UNITY CHRIST CHURCH OF TRUTH SUBDIVISION, **RESUBDIVISION OF LOT 2**

APPLICATION NUMBER 8 DATE April 5, 2007

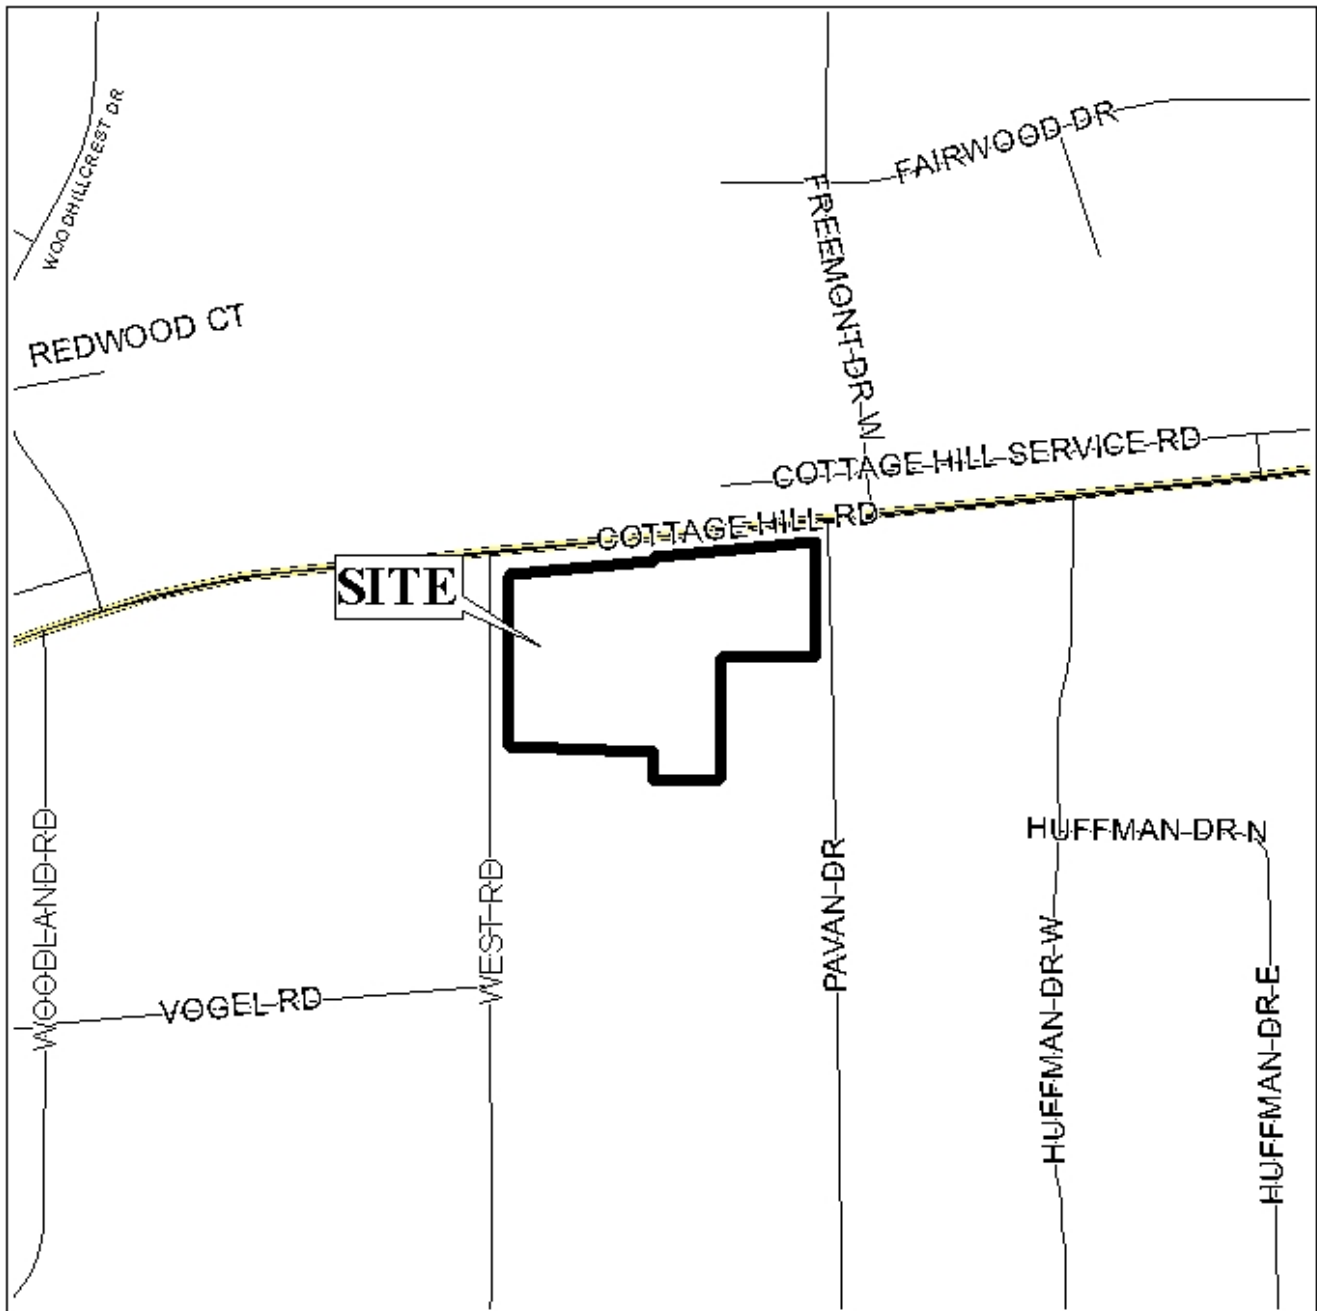
As illustrated on the Vicinity Map the proposed interior lot line bisects the existing dwelling. However, the intent of the proposed subdivision is to create a separate lot from the existing religious facility; therefore, the lot line must be relocated to provide a minimum of 8-foot side yard setback or the dwelling demolished prior to signing and recording of the Final Plat.

- 1) the provision of a 75-foot setback (which includes the required minimum building setback of 25-feet), from the centerline of Cottage Hill Road;
- 2) the placement of a note on the final plat stating that the development is limited to the existing curb cuts; and
- 3) the illustration of the dwelling and the compliance with the setback requirements of the Zoning Ordinance on the Final Plat or the dwelling demolished prior to signing and recording of the Final Plat.
